**PERKINSVILLE ROAD**

**PROPOSED EXPLORATION PLAN**

**DRAFT PLAN OF OPERATIONS**

DRAKE CEMENT LLC

## 4. Trenches

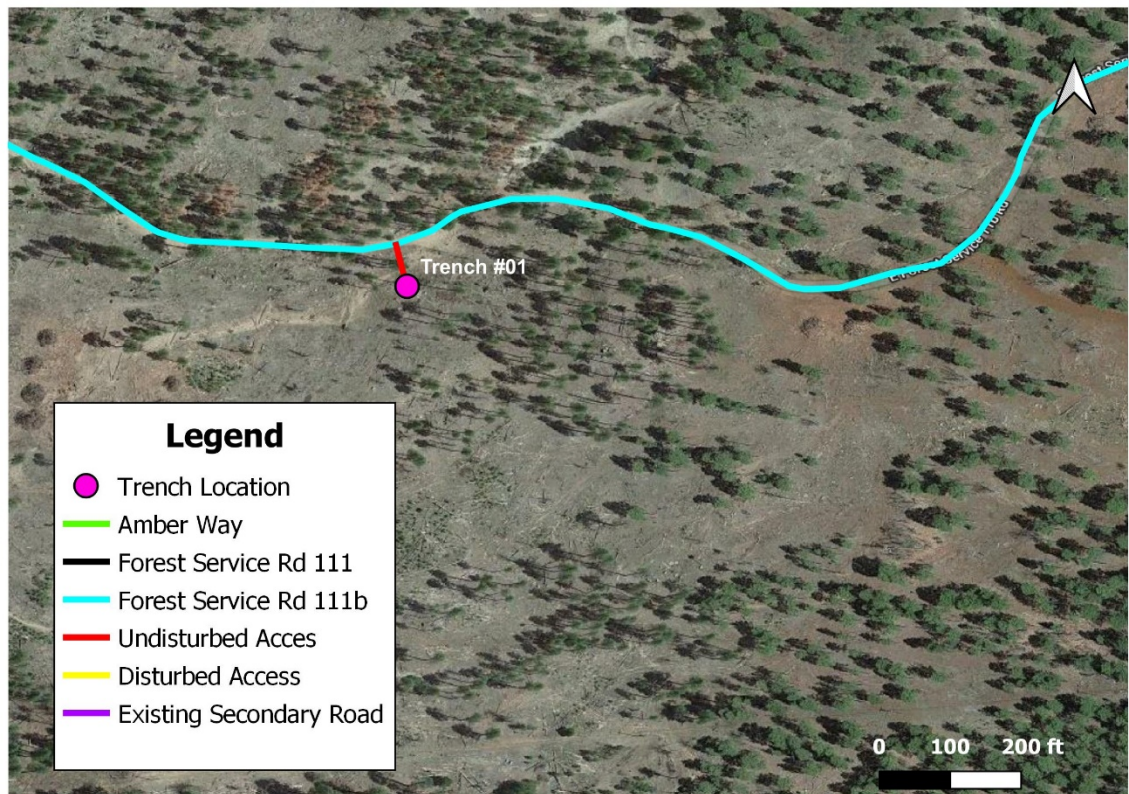
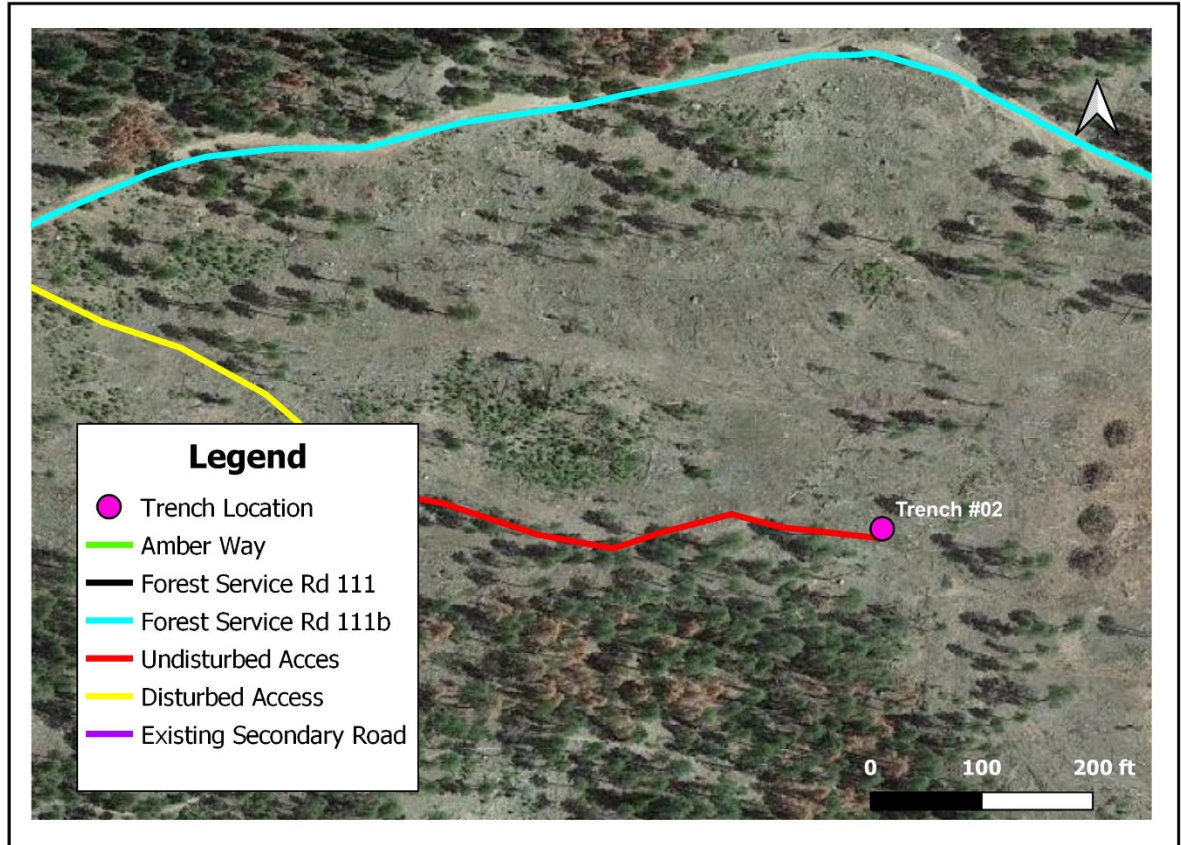
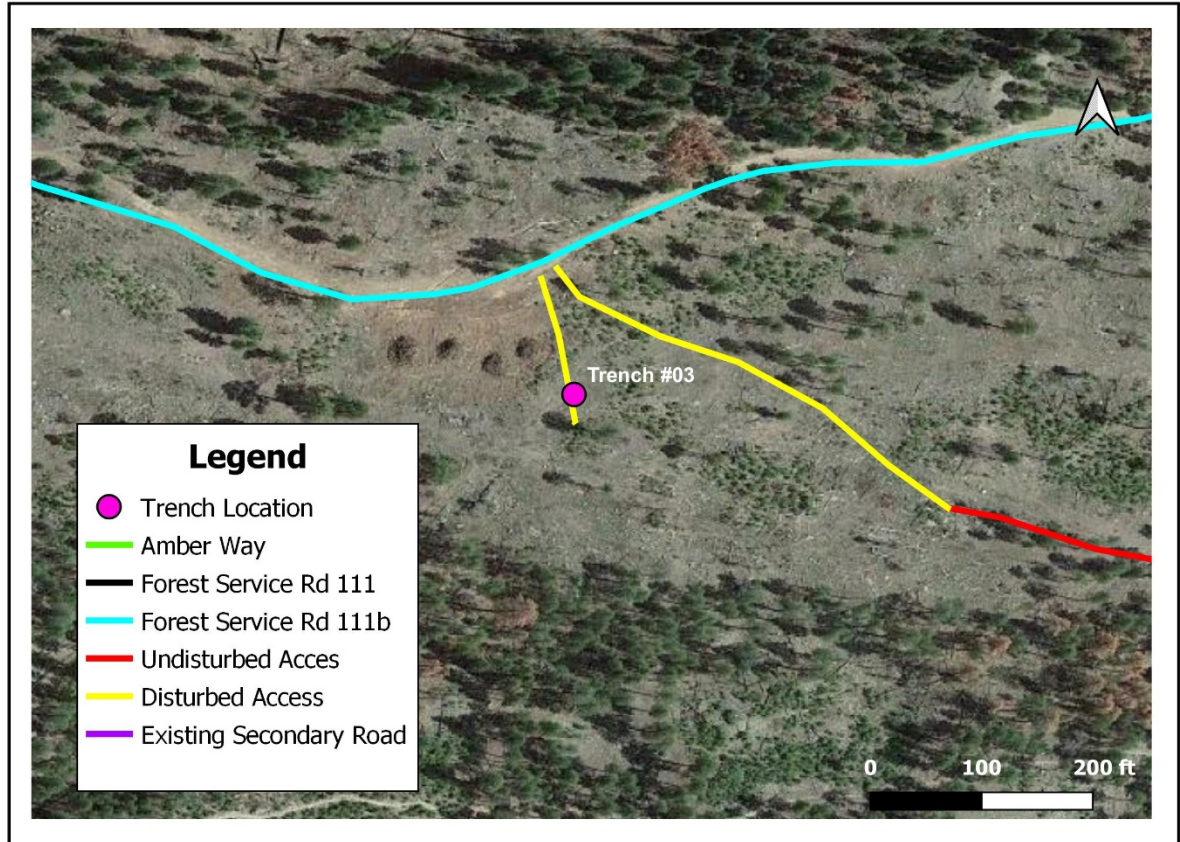
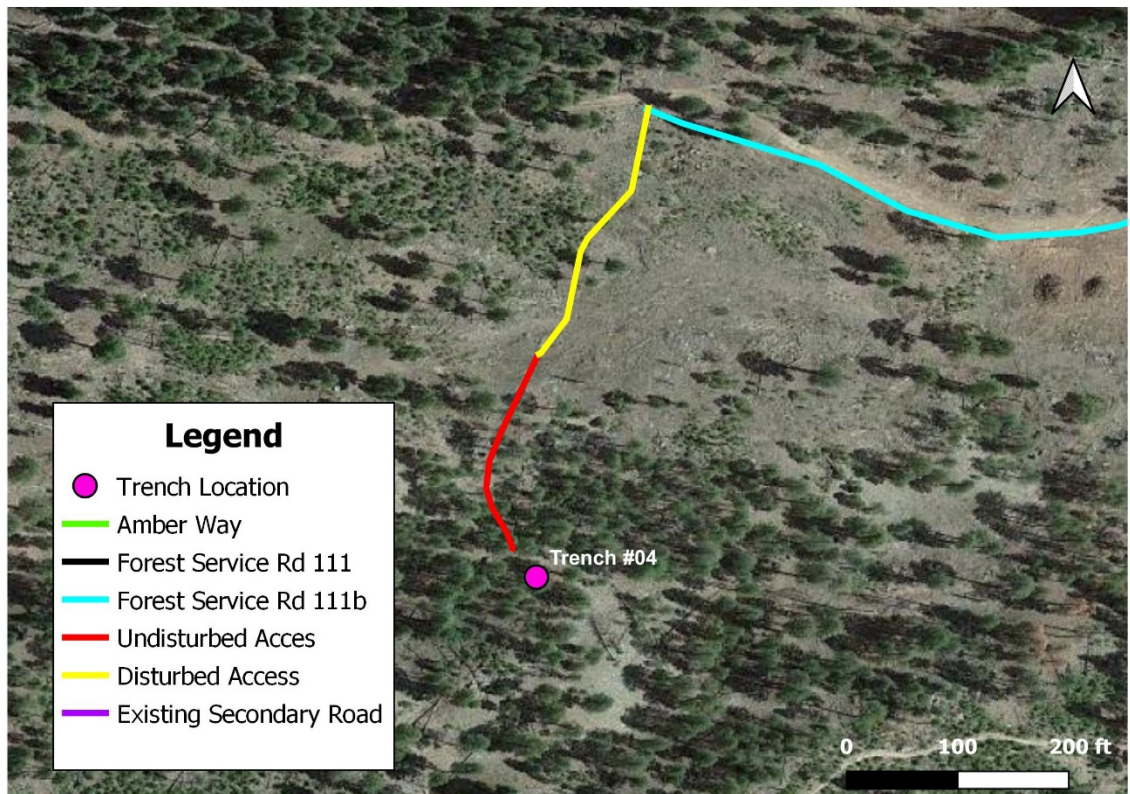
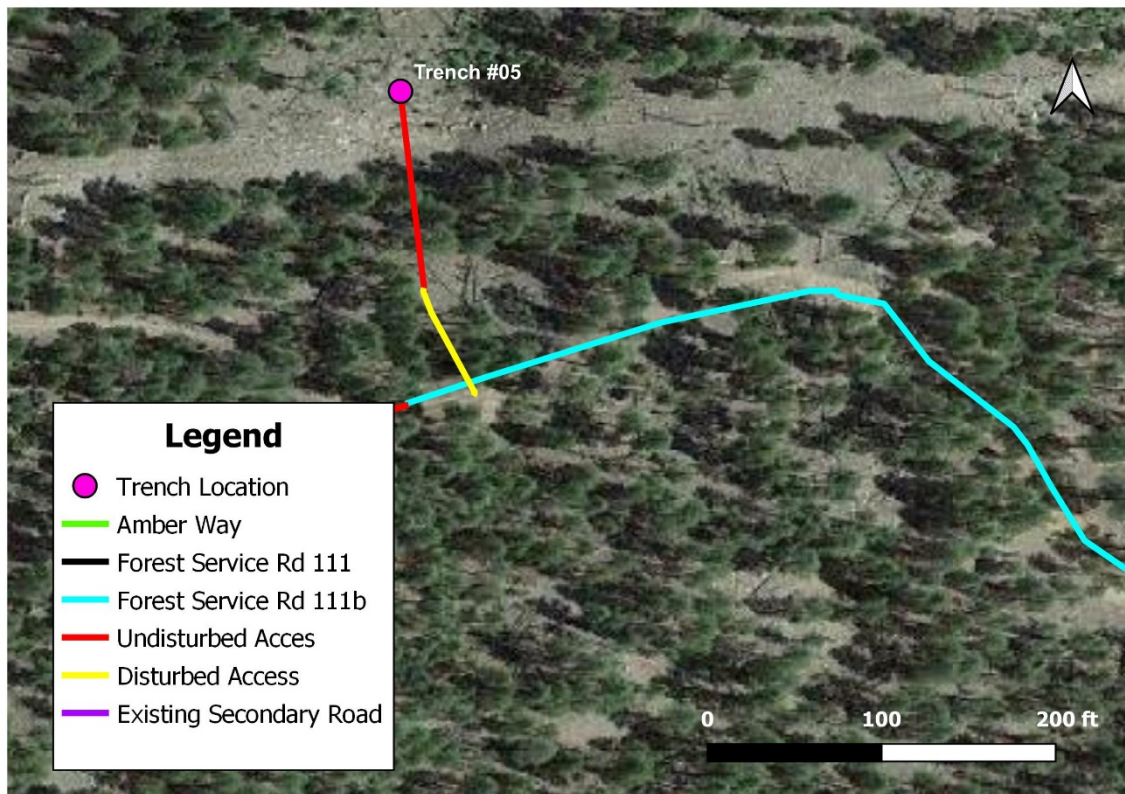
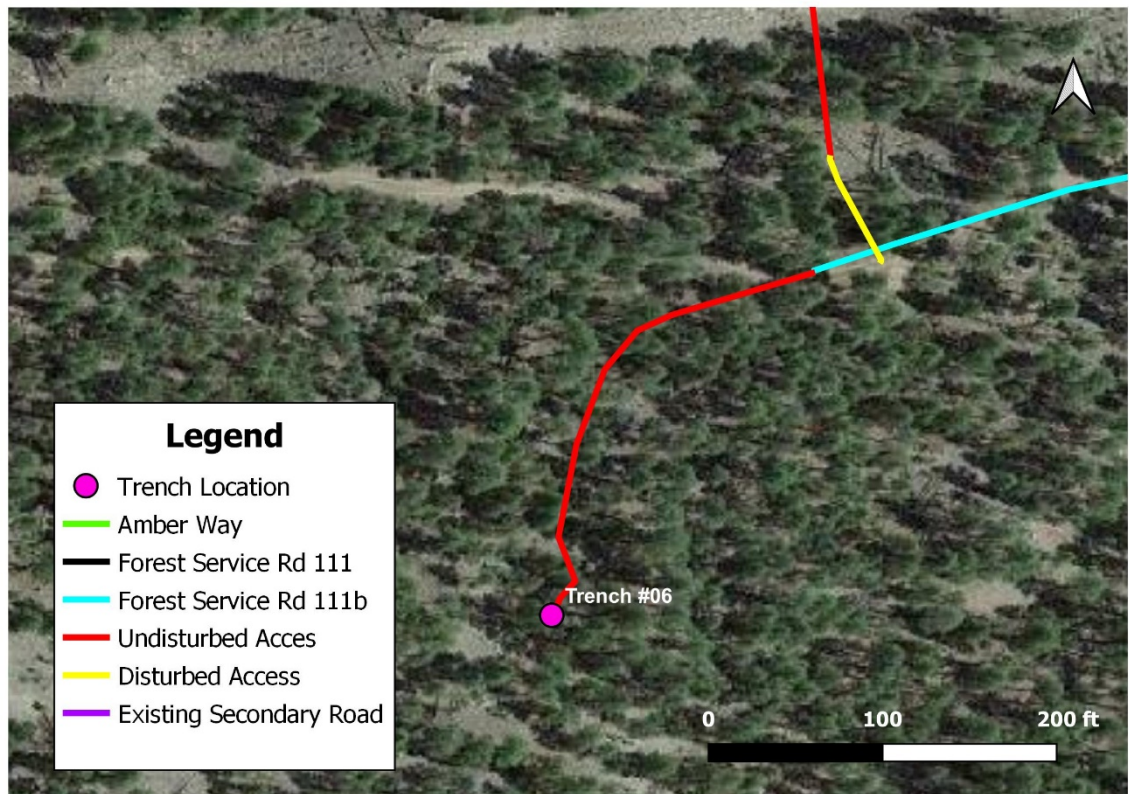
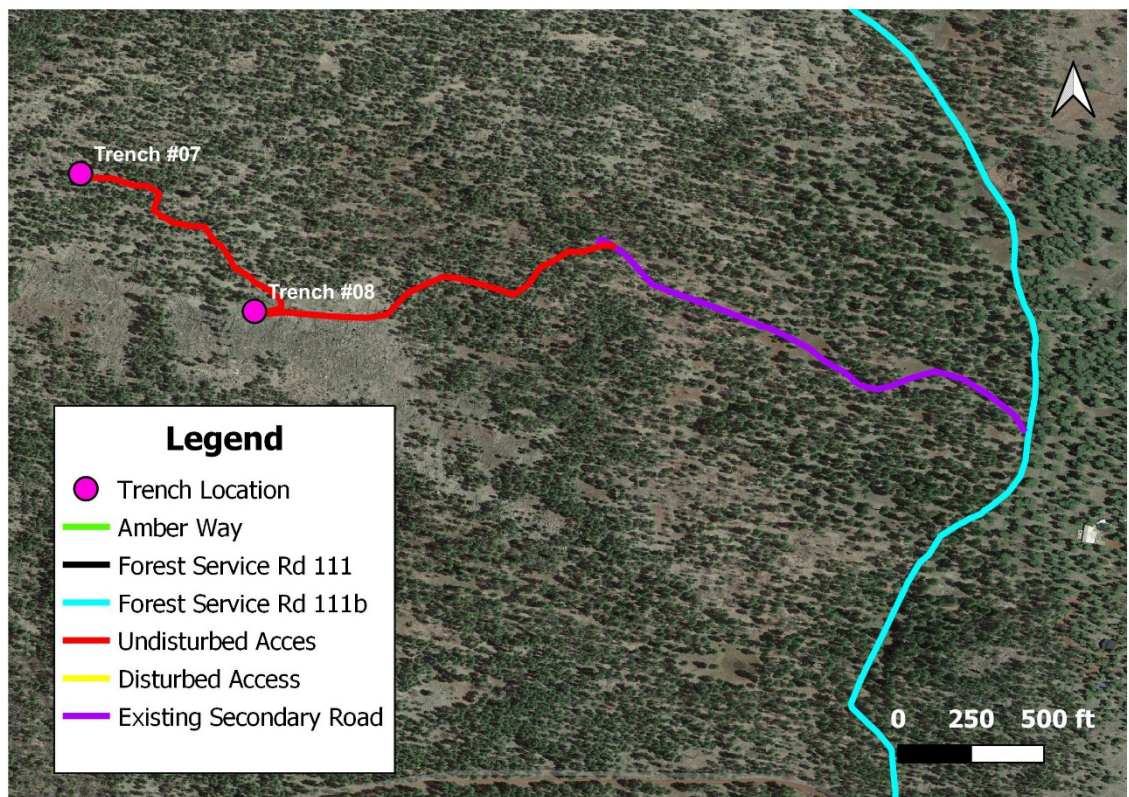
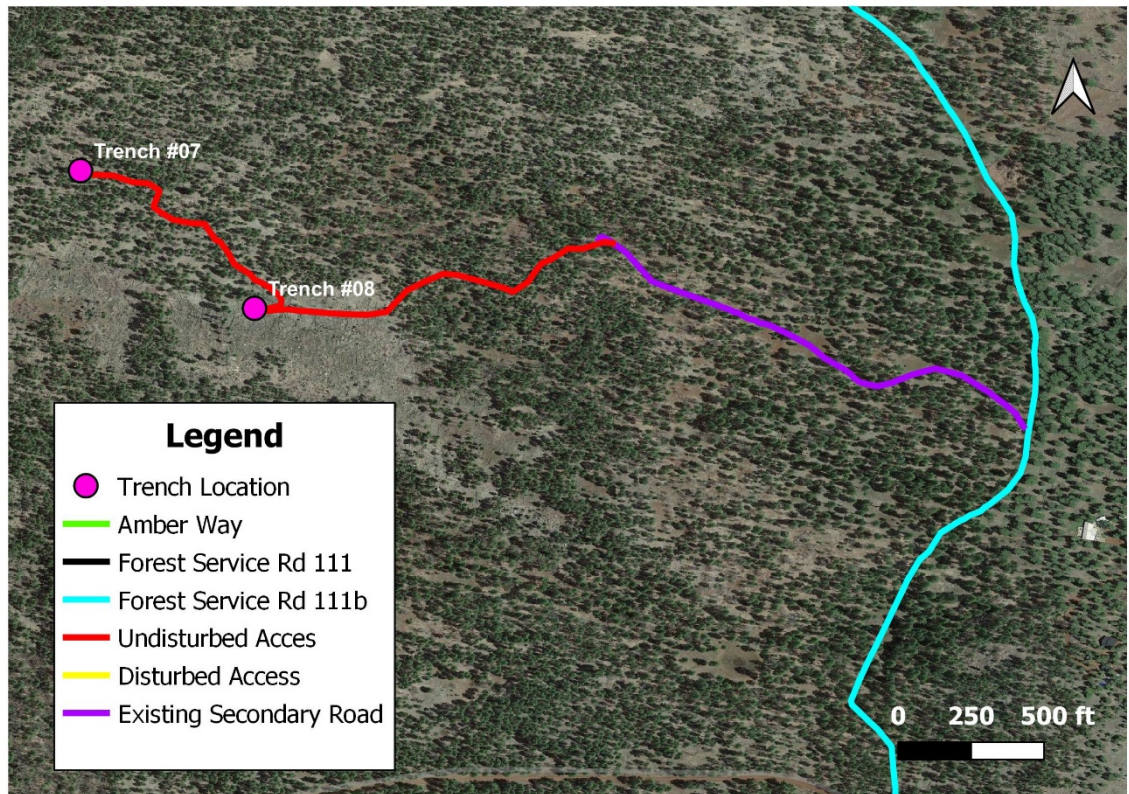
- Many of the trench locations are at a distance from the existing road network in the area. Please be specific regarding the access needs for the various trench locations as per 36 CFR 228.4(c)(2). Specifically, is additional ground disturbance needed, such as road construction and/or clearing of vegetation, to access each trench location? If so, where are the specific routes to be used, how would they be constructed, and what specifications (width, etc.) would be used? Section 6 Project Exploration Updated and Figures Section 4 Revised to provide additional detail.

- Many of the trench locations are at a distance from the existing road network in the area. Please be specific regarding the access needs for the various trench locations as per 36 CFR 228.4(c)(2). Specifically, is additional ground disturbance needed, such as road construction and/or clearing of vegetation, to access each trench location? If so, where are the specific routes to be used, how would they be constructed, and what specifications (width, etc.) would be used?

Access to trench hole locations will be conducted on existing forest roads, existing secondary roads, and existing visibly disturbed areas to the extent practical. Some overland travel in undisturbed locations is proposed to gain access to some of the trench locations. The total additional disturbance area for overland travel is based on the width of the backhoe of 8 feet and the length of the undisturbed area requiring overland travel. Return travel from each trench location will be conducted along the same pathway to minimize any additional disturbance. Trench locations and access routes will be flagged prior to commencing work.

The total proposed area to be disturbed for trenching is 0.15 acres and overland travel is 0.68 acres for a total of 0.83 acres total disturbance for the proposed exploration project. The following disturbance table outlines the proposed disturbance area for overland travel to each trench location.

Activity Area	Overland/Undisturbed Travel Length (feet)	Backhoe Width (feet)	Total Disturbance Area (square feet)
Trench 1	70	8	560
Trench 2	460	8	3680
Trench 3	0	8	0
Trench 4	225	8	1800
Trench 5	140	8	1120
Trench 6	320	8	2560
Trench 7	1090	8	8720
Trench 8	1385	8	11080
Total Overland Undisturbed Area (square feet)		29520	
<b>Total Overland Undisturbed Area (acres)</b>		<b>0.68</b>
